CITY OF YPSILANTI
Planning Commission MEETING
Wednesday, February 15, 2023 @ 7:00 PM
Council Chambers
One South Huron, Ypsilanti, MI 48197

Staff Review
Special Use and Site Plan Applications
206-210 N Washington Street

Applicant	Avalon Housing Michael Appel, Representative
Project	206-210 N Washington New Apartments
Public Hearing Date	February 15, 2023
Location	206-210 N Washington (Parcel 11-11-40-411-003 Legal Description *OLD SID - 11 11-441-334-00 YP CITY 44W-24 S 22' OF LOT 331 & ALL OF LOT 334 & N 1/2 OF W 1/4 OF LOT 335 & VAC ALLEY ADJ TO REAR OF LOT 334 NORRIS & CROSS ADDITION. 206-210 N WASHINGTON.
Zoning	CN – Core Neighborhood
Action Requested	Special Use Permit Approval and Site Plan Approval
Staff Recommendation	Approval

Figure 1: Building Zones

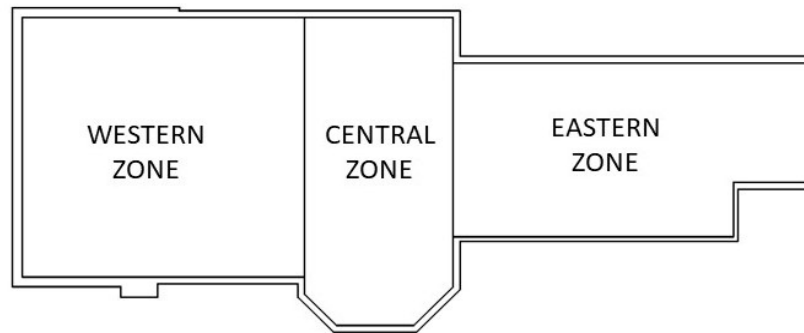
For the purposes of this report and analysis, the tower has been dividing into three zones: Eastern, Central, and Western as shown in Figure 1. The construction methods and materials are relatively uniform within the zones.

Figure 3: Eastern Zone Building Cross Section (Courtesy CDI Architects)

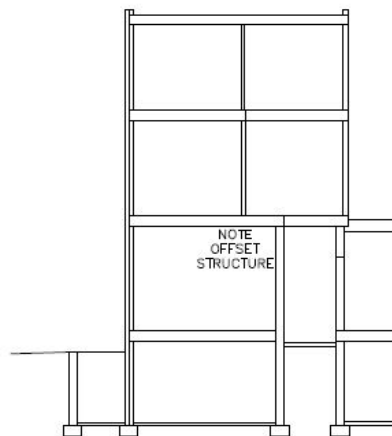
The interior bearing wall on the second and third floors is offset from the foundation by nearly two feet. This creates a situation where the second floor joists are carrying the full loading from the bearing walls above as shown in Figure 3. At the current span, the 2nd floor joists would be overloaded and not meet the minimum deflection requirements.
